## Service Bulletin

Location Charles City  
 Subject Transmission –  
 1265-1270 Tractors  
 Number 430 741  
 Date 8-7-75  
 File C Transmission

This bulletin supersedes and cancels bulletin 430 698 dated 2-18-75 to provide additional information relating to transmission gear disengagement on 1265-1270 tractors.

Fig. 1.

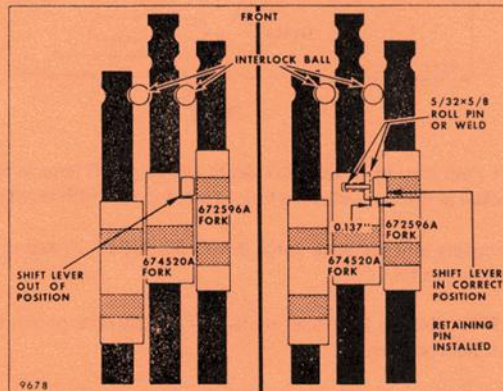
1. Three conditions may contribute to disengagement of 1st and 4th gear.
  - a. 672 416A Interlock Ball for 674 520A Hi-Low Range Shift Fork may have been left out at assembly. Interlock ball locks center rail in position which in turn is used to lock transmission in gear with end of shift lever (Fig. 1).

- b. Notch in 674 520A Shift Fork may be of excessive depth allowing shift lever to move out of position (Fig. 1). 672 596A Fork will not be locked in position, allowing fork to move to rear with resultant gear disengagement.
- c. End of shift lever not dropping into interlock notch in 674 520A Fork or end of shift lever and/or notch in fork worn so lever does not lock in position.
2. Excessive material on 672 596A Shifting Fork may contact 672 492A Gear preventing complete engagement of 671 123A Gear with 31-290 2114 Reverse Gear.
3. 670 228A Cover may be machined incorrectly. Cover should clamp lower shaft bearing and gasket simultaneously. As gasket is crushed lower shaft is forced to rear until snap ring contacts case preventing lateral movement of shaft. If 670 228A Cover has excessive counterbore, shaft is allowed to move forward with resulting disengagement of 3rd and 6th gear.

Interlock notch in 674 520A Fork must be 0.137 inch (3.5 mm) deep to accept end of shift lever to interlock 1st and 4th gear shift fork. Inspect end of shift fork for possible wear or damage on interlock face.

Drill 5/32-inch hole approximately 1/2-inch deep and install 933 165 Roll Pin (5/32 x 5/8-inch) (Fig. 1). Use care to catch all shavings while drilling hole in fork. CAUTION: Pin must leave 0.137-inch (3.5 mm) notch (Fig. 1).

Fig. 2.

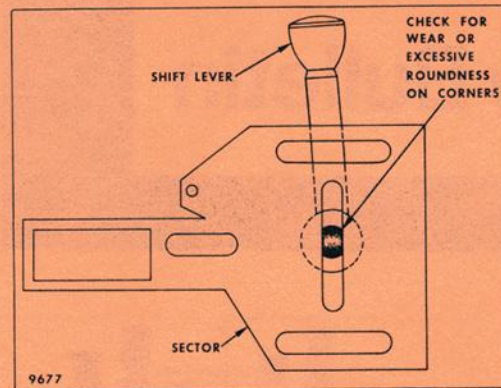
Check that ball on end of shift lever is not worn. Shift ball may be built up to width of slot in 31-290 0214 Sector (Fig. 2).

Fig. 3.

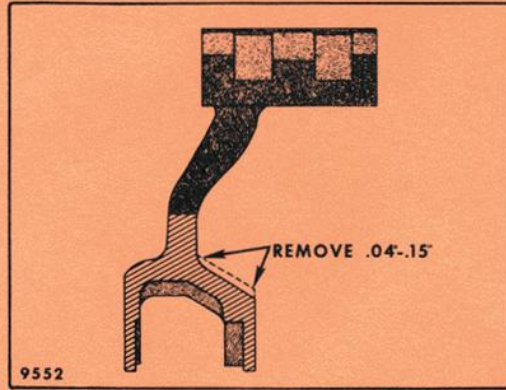
If interference exists between 672 492A Gear and 672 596A Fork, remove 672 596A Fork and grind as shown (Fig. 3). Upon reassembly determine that fork does not contact inner diameter of 672 492A Gear; when in full detent, reverse gear position.

Fig. 4.

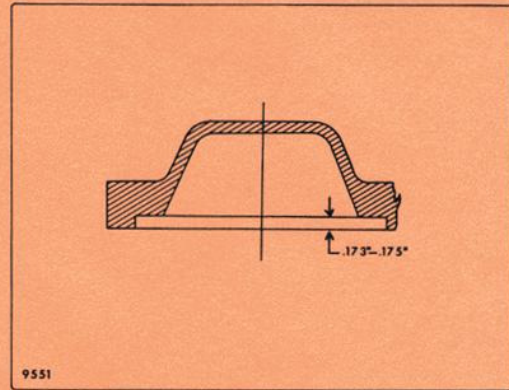
If problem exists, remove 670 228A Cover and check cover as shown in Fig. 4. If counterbore exceeds .173-.175 inch in depth, purchase and install 670 228A Cover or mill existing cover to specification.
